Service Bulletin

Bulletin No.: 20-NA-040

Subject: Pickup Box Power Endgate May Not Open on Initial Press, or May Not Open at All

5049815

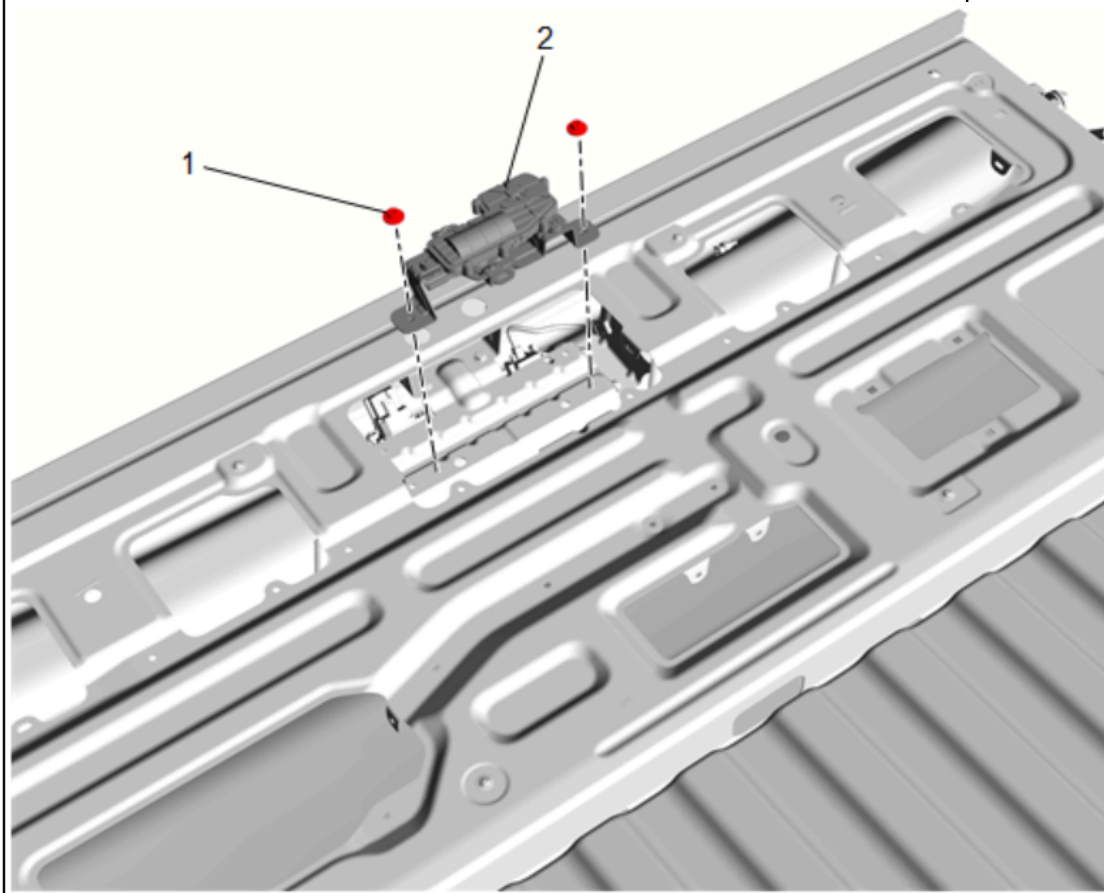
Involved Region or Country	North America, Europe, Russia, Middle East, Israel, Palestine, South America, Philippines, Australia, New Zealand, Egypt, Africa, South Africa
Additional Options (RPOs)	Equipped with QK1 and QK5
Condition	Some customers may comment on the power endgate may not unlatch or drop on first try, or under some conditions, it may not open at all.
Cause	The cause of the condition may be a combination of excessive spring force and low available voltage, which may cause the latch actuator to fail to function.
Preliminary Procedure	<p>Some vehicles, which have a tonneau cover installed, may be affected by a similar Condition, however the Cause and Correction are completely different from this bulletin. On these vehicles, it will be necessary rule out the tonneau cover as the possible Cause of the condition:</p> <ol style="list-style-type: none"> 1. Open the rear end panel of the tonneau cover. 2. Cycle the power tailgate 5 times using push button activation for auto open and auto close. <ul style="list-style-type: none"> • If the power endgate Does function properly, DO NOT proceed with this bulletin repair, but move on to Bulletin # 20-NA-044 and complete the tonneau adjustment procedure. • If the power endgate still DOES NOT function properly, continue on and complete the Correction outlined in this bulletin.

Upon verifying the condition, replace the pickup box endgate lock actuator (2) with an improved design service part. Refer to *Pickup Box Endgate Lock Actuator Replacement (Power)* in SI.
